Access Compliance Report

Public Rights-of-Way

(Curb Ramps)

Intersection ID: 22882	Main Street: SARDIS_POINTE_RD	Cross Street: SARDIS_RD	Location: SW
ADA ID: 111ACBE46DAD	Ramp Type: Perp	Initial Pass/Fail: Fail	Overall Compliance: No
Severity Score: 33.75			
Codes/Mitigation Info/Possible Solution		Field Measurements/Component Compliance

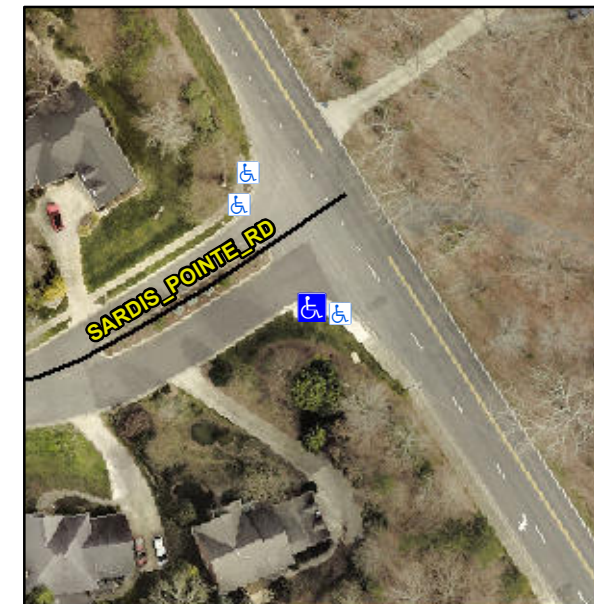
Not Found, R304.5.1, R304.5.3

Compliance	Description	Data	Compliance	Description	Data
N/A	Ramp Length (in)	71.5	Yes	Ramp Slope (%)	6.2
No	Ramp Width (in)	46.5	No	Ramp XSlope (%)	11.8
N/A	Flare Type LT	N/A	N/A	Flare Type RT	N/A
N/A	Flare Slope LT (%)	N/A	N/A	Flare Slope RT (%)	N/A
N/A	Flare Traversable LT?	N/A	N/A	Flare Traversable RT?	N/A
N/A	Landing Length (in)	N/A	N/A	DWS Provided?	N/A
N/A	Landing Width (in)	N/A	N/A	DWS Contrast?	N/A
N/A	Landing Slope (%)	N/A	N/A	DWS Length (in)	N/A
N/A	Landing X Slope (%)	N/A	N/A	DWS Full Width?	N/A
N/A	Landing Curb? (Y/N)	N/A	N/A	DWS Offset (in)	N/A
N/A	Shared Landing?	N/A			
N/A	Gutter Ponding?	N/A	N/A	Gutter Slope (%)	N/A
N/A	Gutter Lip Ht (in)	N/A	N/A	Gutter X Slope (%)	N/A
N/A	Painted X Walk1?	No	N/A	Painted X Walk2?	N/A
	X Walk 1 Direction	To NW		X Walk 2 Direction	N/A
N/A	X Walk 1 Width (in)	N/A	N/A	X Walk 2 Width (in)	N/A
	X Walk 1 Slope (%)	0.6		X Walk 2 Slope (%)	N/A
	X Walk 1 X Slope (%)	8.6		X Walk 2 X Slope (%)	N/A

Remove & Replace Entire Ramp.
